PCO #23-001

Project: 0573-02 - Hillcrest HS - Drainage Improvements
11800 Indiana Ave.
Riverside, California 92503

Prime Contract Potential Change Order #23-001: CE #008 - Added Time/Labor for Existing Slurry Remediation at Judge Netting Post Footings

**EXISTING FIELD NETTING PIER
SLOT-CUT DIAGRAM**

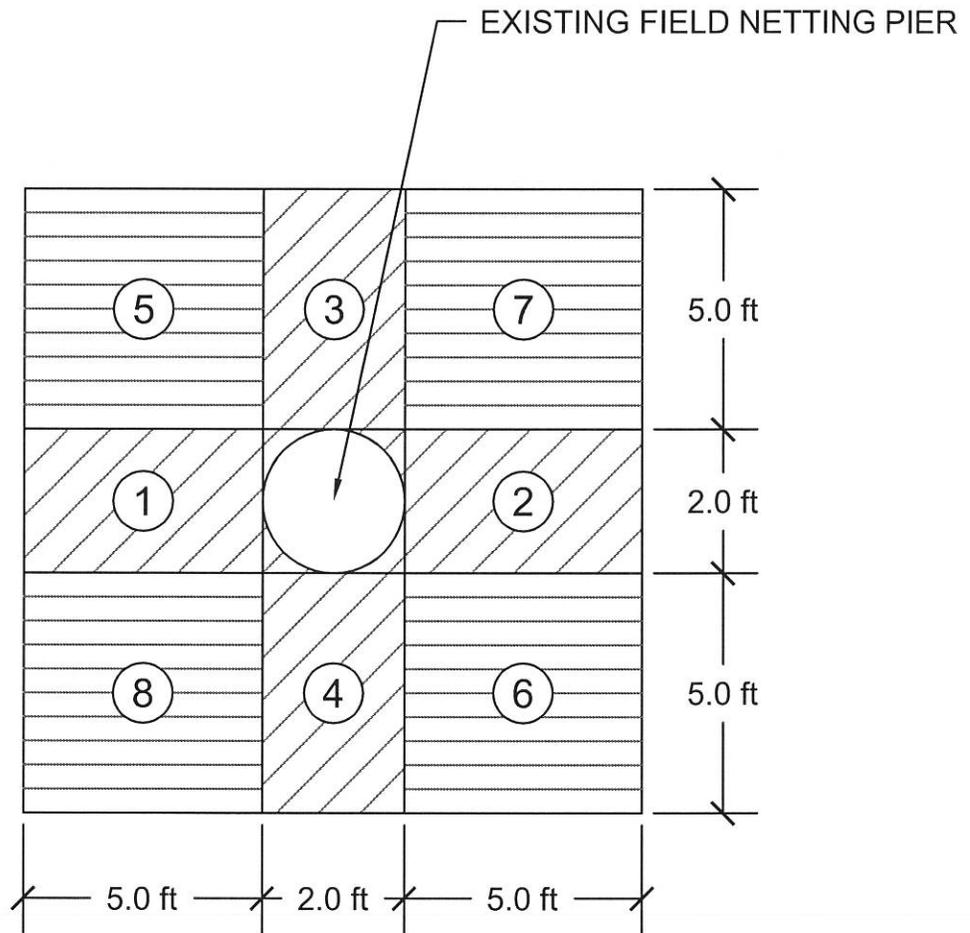
Per Byerly's Report #7134 (Enclosure 2), Neff construction provided slot trenching with a concrete slurry backfill around (2) of the Judge Netting Pole's footings to provide shoring for these footings during the adjacent slope re-grading. During the Site Plumbers scope of work, they encountered this slurry in (2) locations while installing the new Storm Drain Piping and Rodent Barrier. The cost of the PCO represents the added labor and equipment time needed to trench through the slurry added per Byerly's report.

Once the slurry in the four initial trenches has set, the soil adjacent to the trenches should be overexcavated to a depth of 5 feet below the final ground surface and extending at least 5 feet perpendicular to the trenches, as also shown on Enclosure 2. When the excavation of each of these secondary excavations is complete, that excavation should also be backfilled with sand/cement slurry containing at least two sacks of cement per cubic yard. Each of these excavations should be backfilled with slurry the same day it is excavated. No excavation should be allowed to stand open overnight.
